REVISIONS TO SITE PLAN (02/08/01)

SITE PLAN
ISLAND CLUB RESORT
POLK COUNTY, FLORIDA

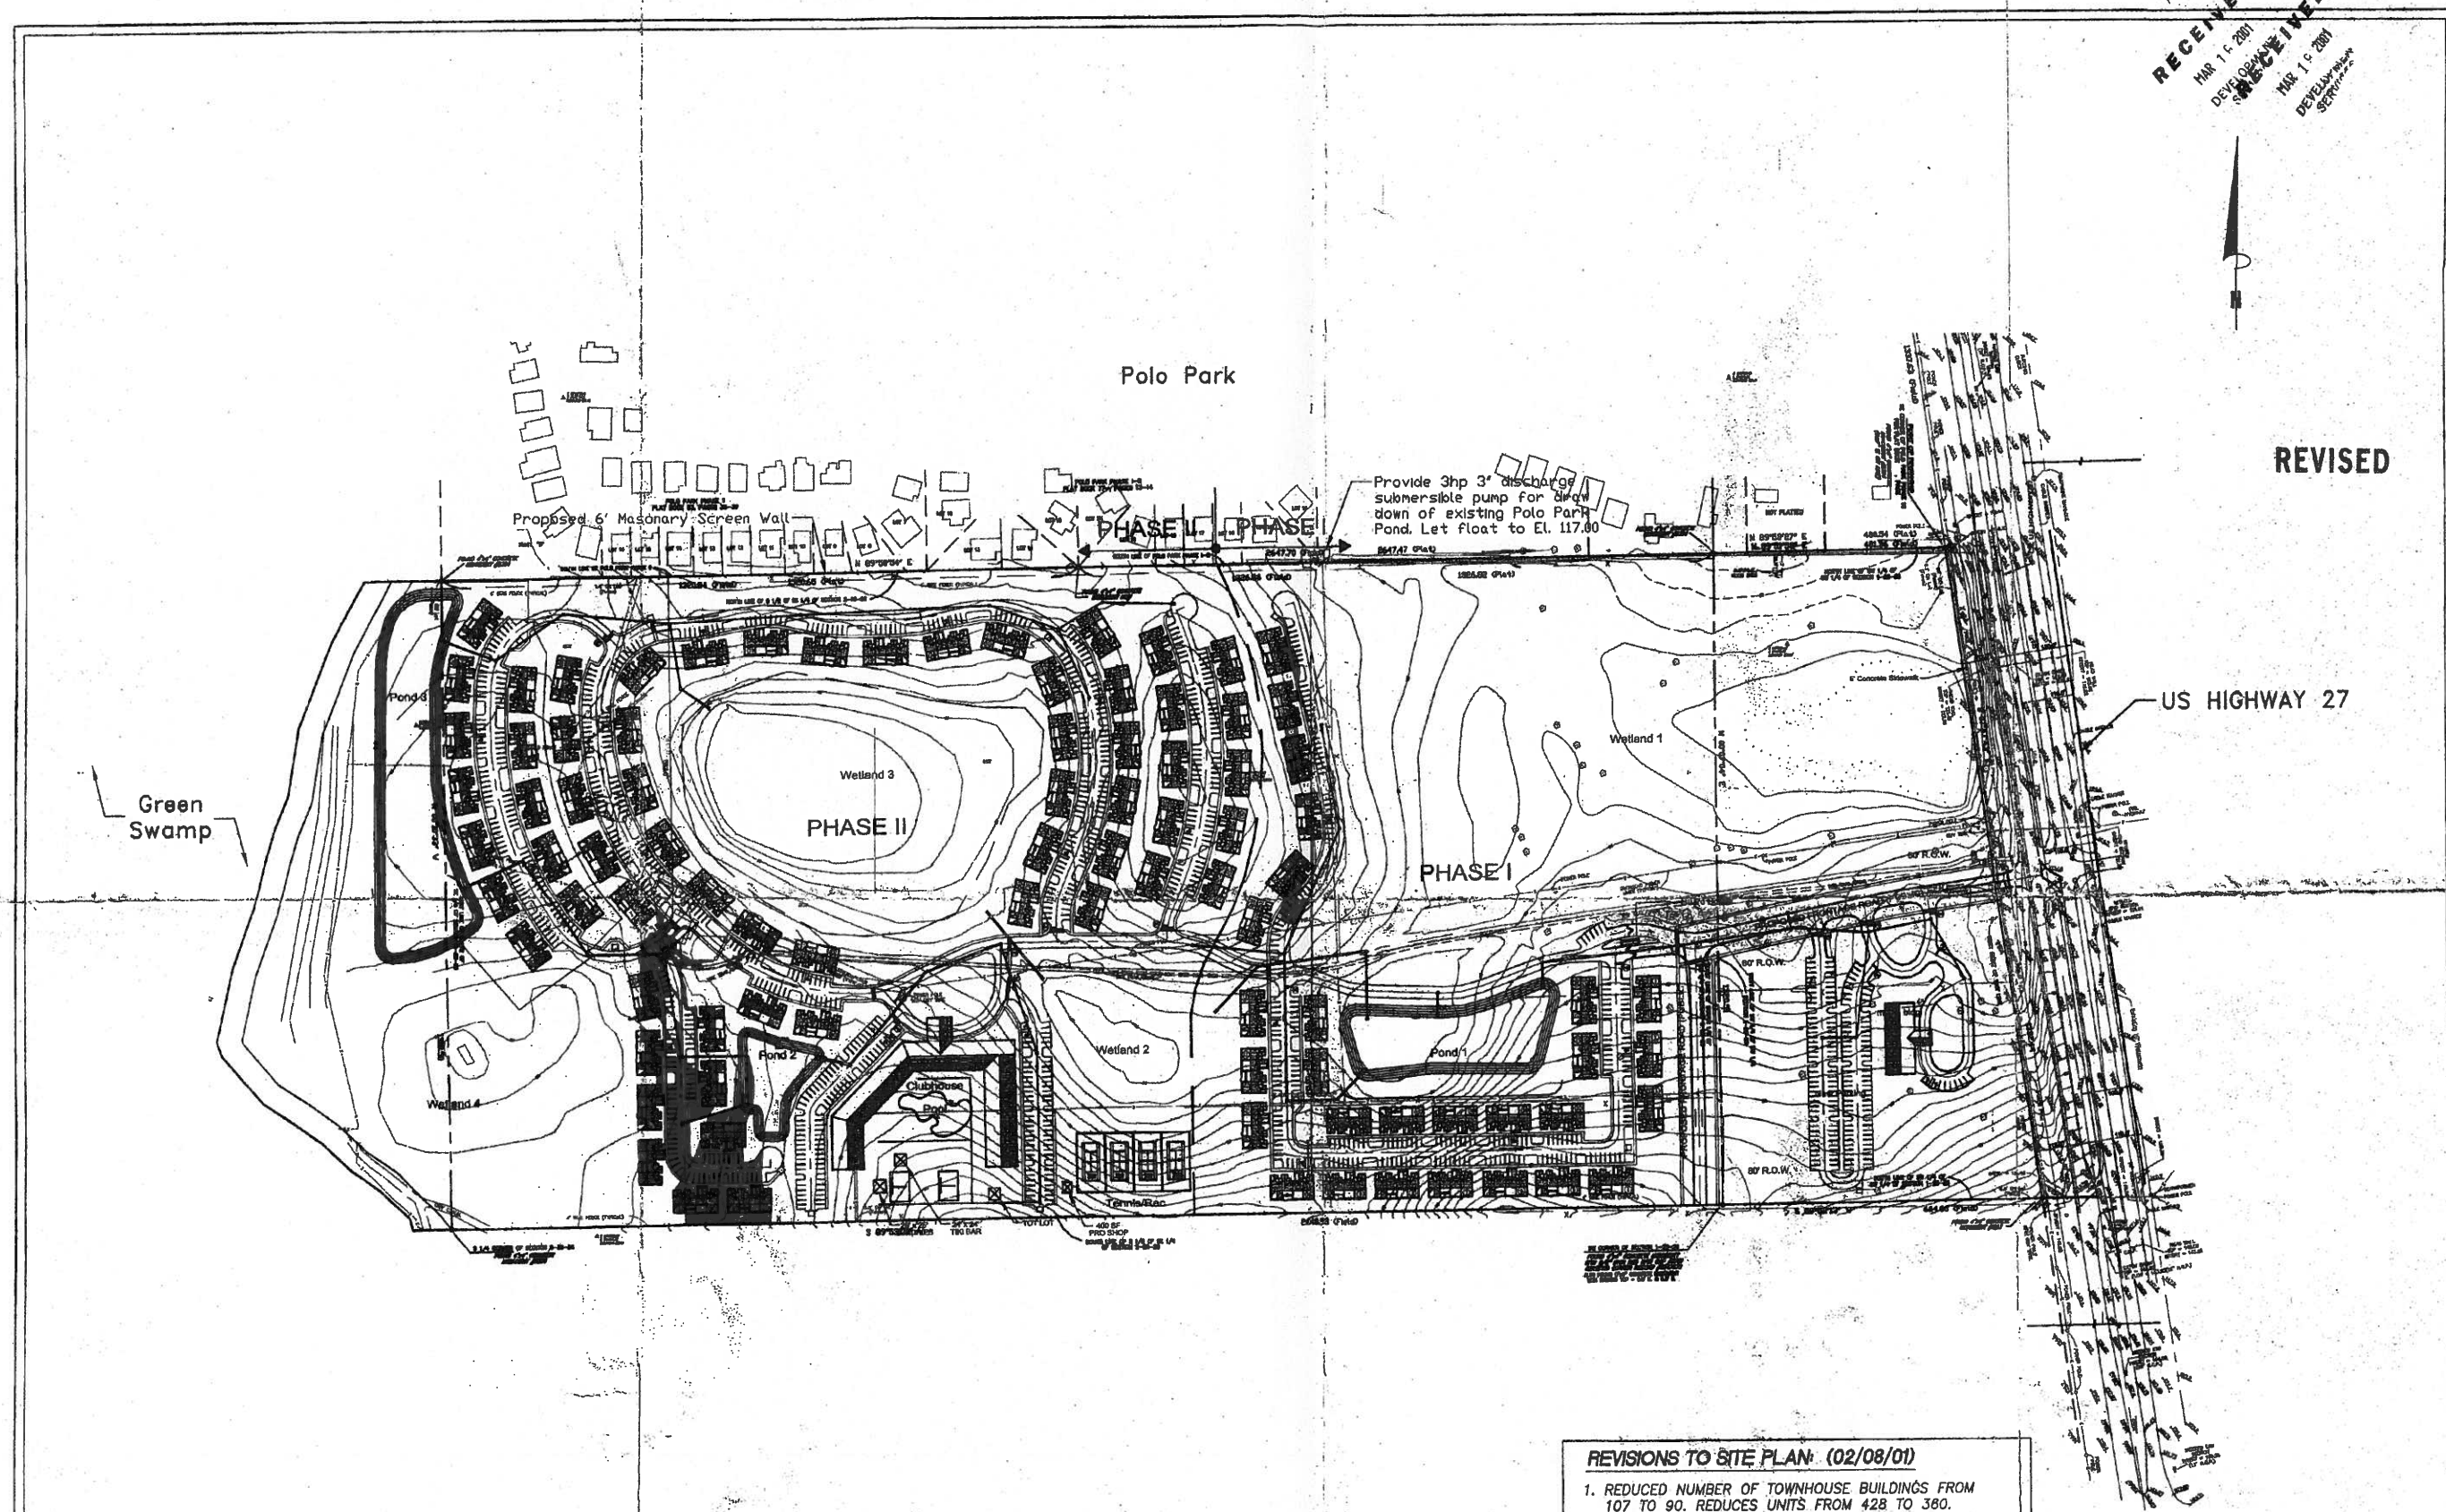
1. REDUCED NUMBER OF TOWNHOUSE BUILDINGS FROM 107 TO 90. REDUCES UNITS FROM 428 TO 360.
2. REMOVED BUILDINGS ALONG POLO PARK COMMON PROPERTY LINE.
3. MOVED BUILDINGS WITHIN CULDE-SAC FURTHER AWAY FROM POLO PARK PROPERTY LINE.
4. ADDED 6' HIGH MASONARY WALL ALONG POLO PARK WEST OF WETLAND.
5. ADDED 3HP DRAWDOWN PUMP AT POLO PARK POND TO TIE TO PROPOSED FORCE MAIN BY POLK COUNTY.
6. REVISED SEWER, WATER AND DRAINAGE DUE TO SHIFTS IN ROADWAY ALIGNMENTS MADE DURING BUILDING REMOVAL AND RELOCATION.
